City of Ramsey
Agenda
Environmental Policy Board (EPB)

Consider Natural Resources Aspects of Site Plan for U-Haul (Project No. 24-115); Case of U-Haul

Landscape Plan with Comments

Consider Natural Resources Aspects of Site Plan for Voice of Hope Church (Project No. 24-114); Case of Voice of Hope Church

Irrigation Notes + Requirements:

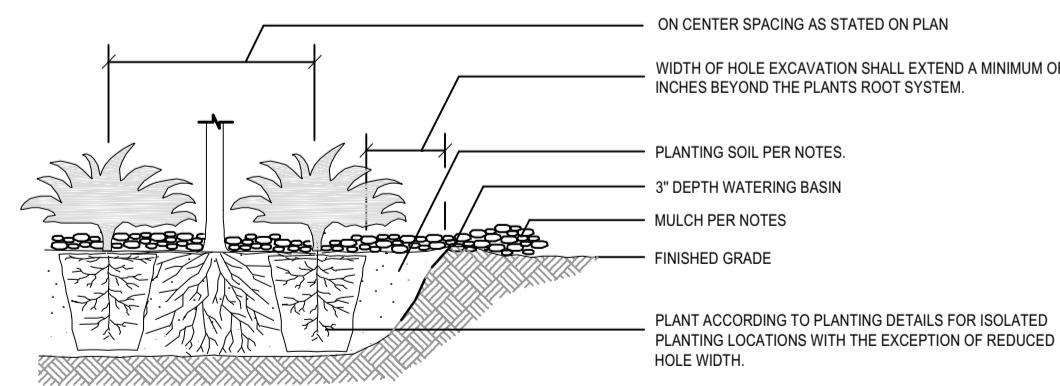
Please add a note under Irrigation Notes specifying that in addition to the required rain sensor, some form of water efficient technology, such as a smart controller, shall be installed as part of the irrigation system.

TREE PLANTING KEY:

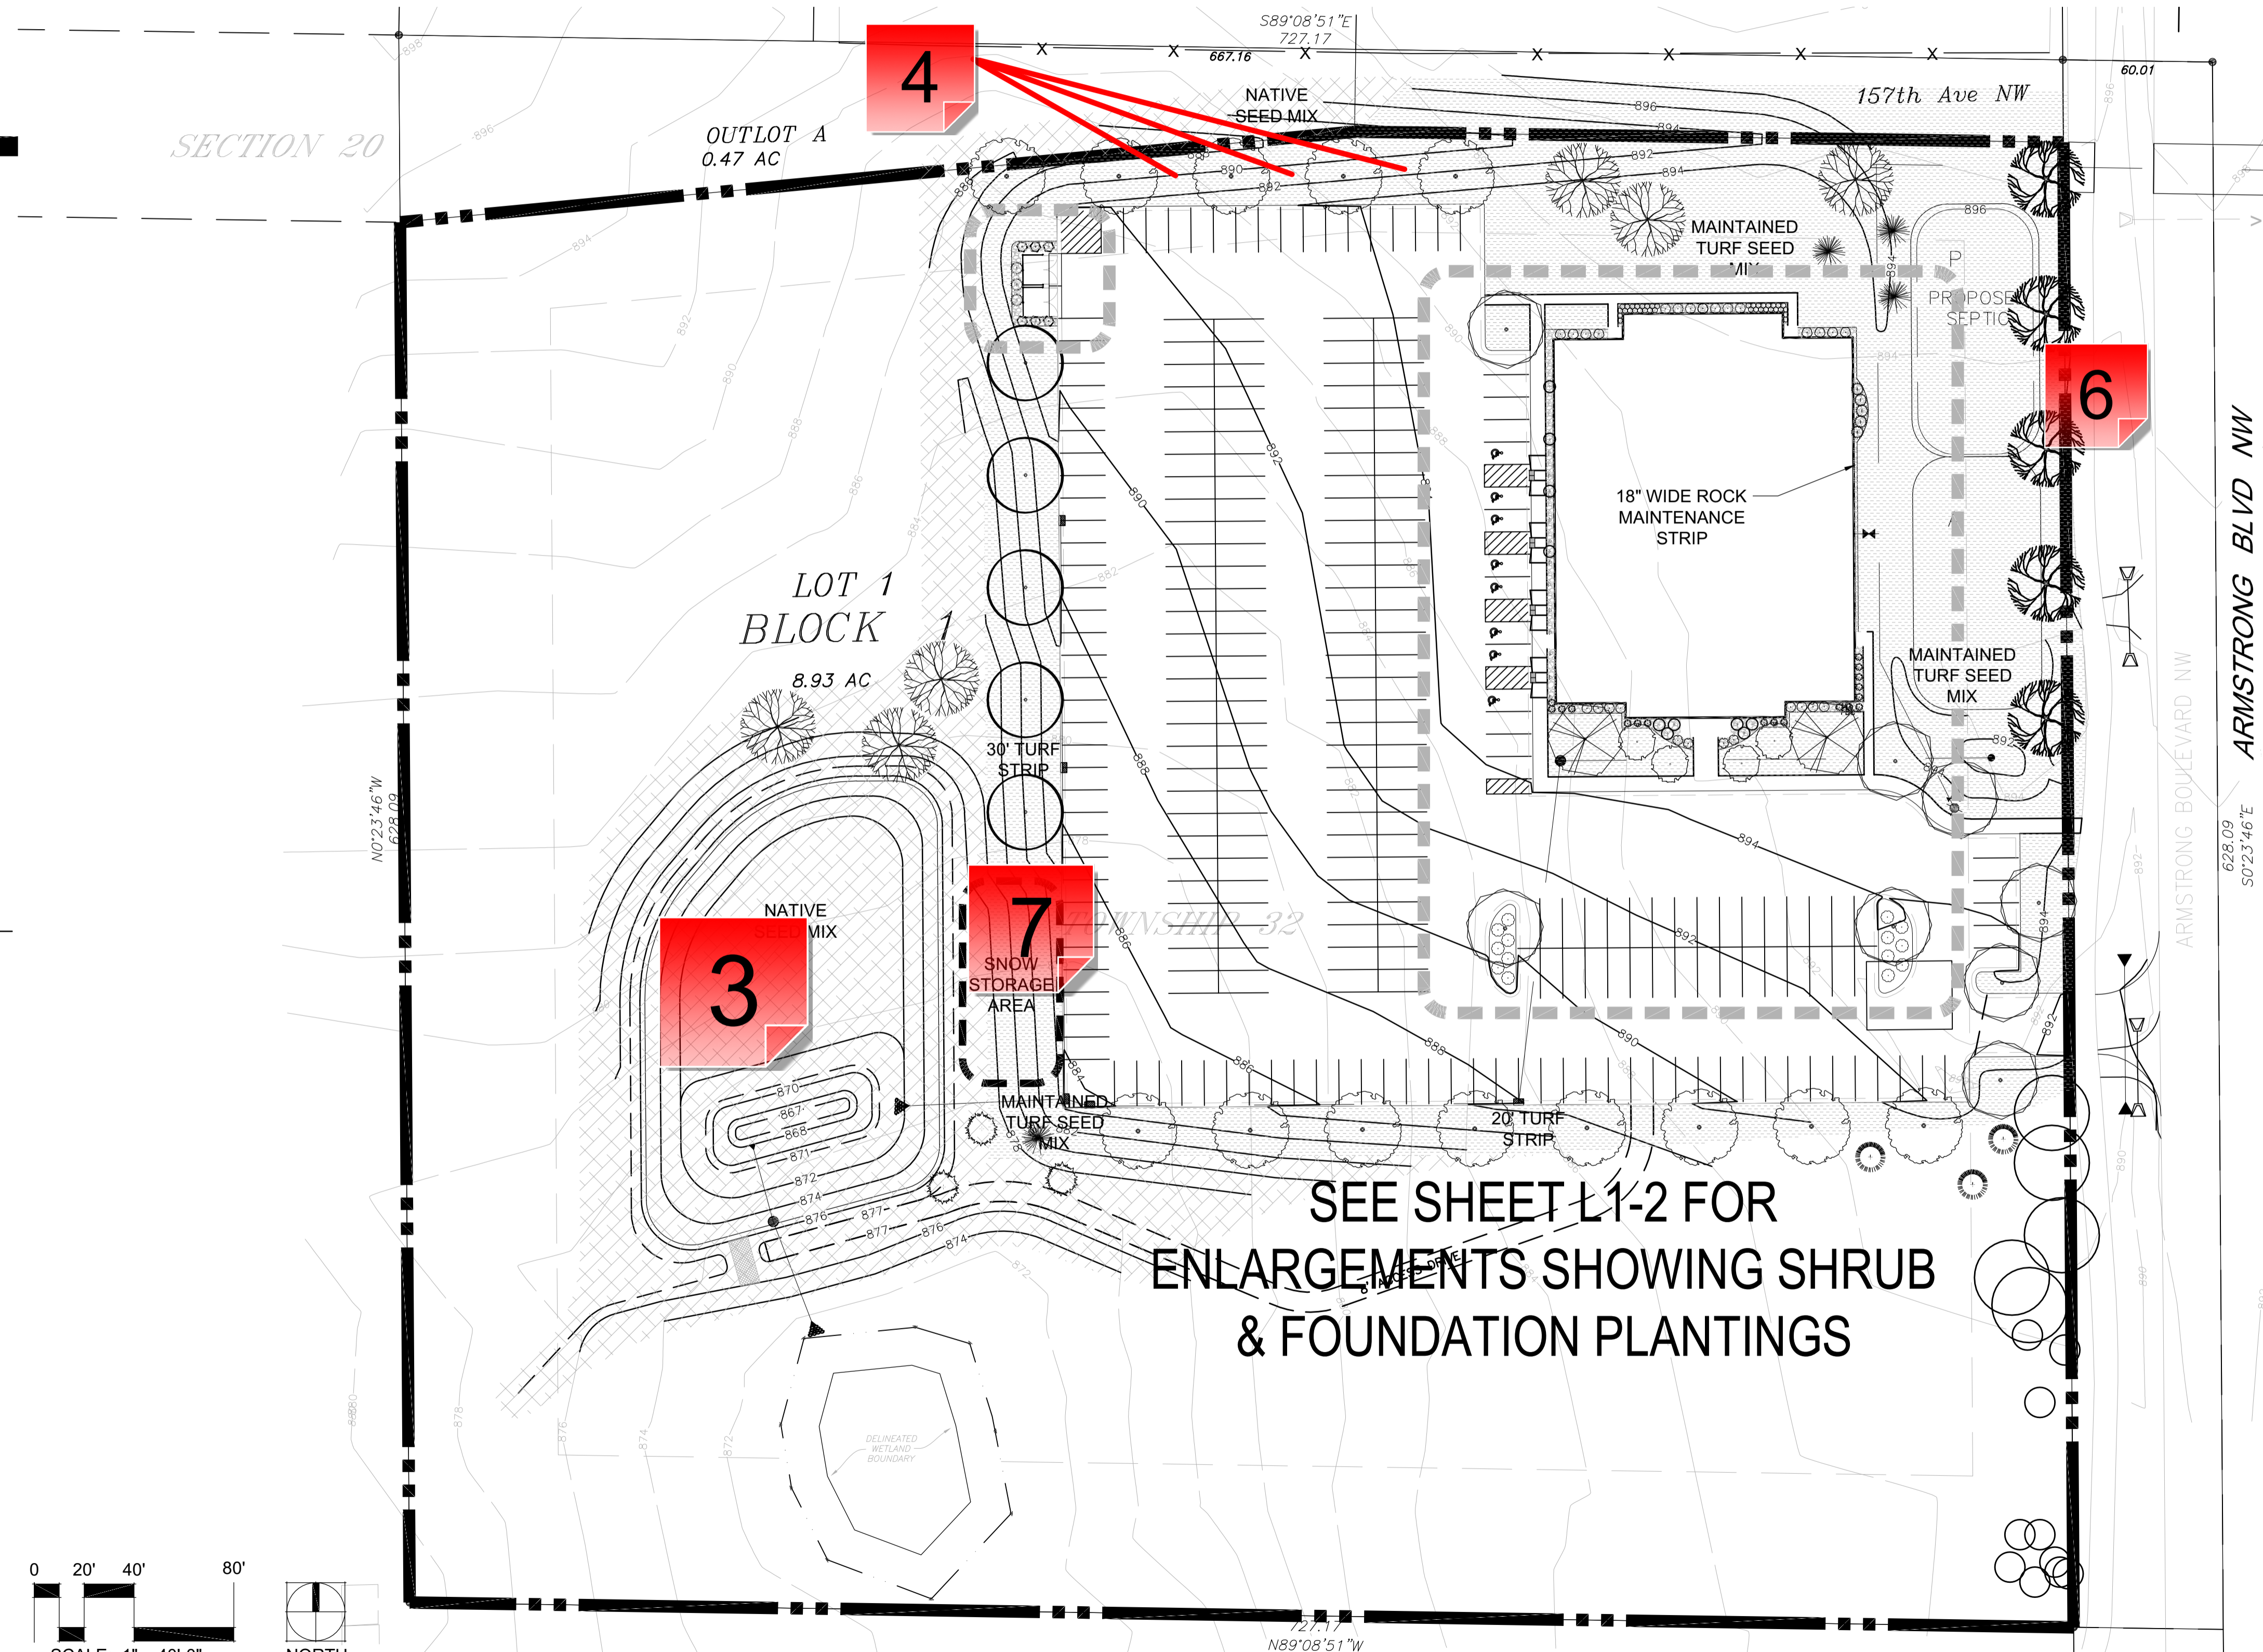
If there are none of this species proposed to be planted, please eliminate from the Planting Key

Please revise the minimum height for both Black Hills Spruce and Austrian Pine to be at least six (6) feet.

A 3-5 year maintenance plan needs to be prepared and submitted. This should provide clear, step by step instructions for the property owner to conduct the necessary maintenance to ensure the native seeding gets established.

Please consider adding taller growing evergreen shrubs in between these trees to provide some screening of headlights from shining into the adjacent residential property. An alternative to plantings, a privacy fence could also be installed.

Please increase the number of evergreen trees to be installed. At least 25% of the plantings shall consist of evergreen trees. A minimum of twelve (12) evergreens need to be planted (48 x 25% = 12).

Will these trees create any conflicts with the proposed drainfield area?

7 - Snow Storage

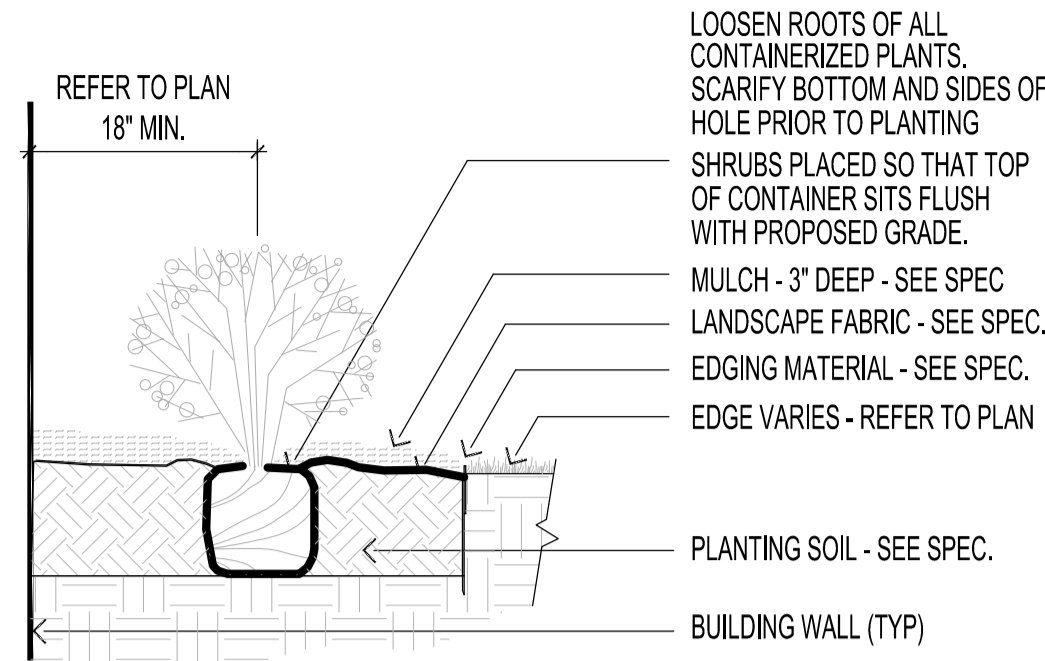
Is this sufficient area for snow storage for this size parking lot?
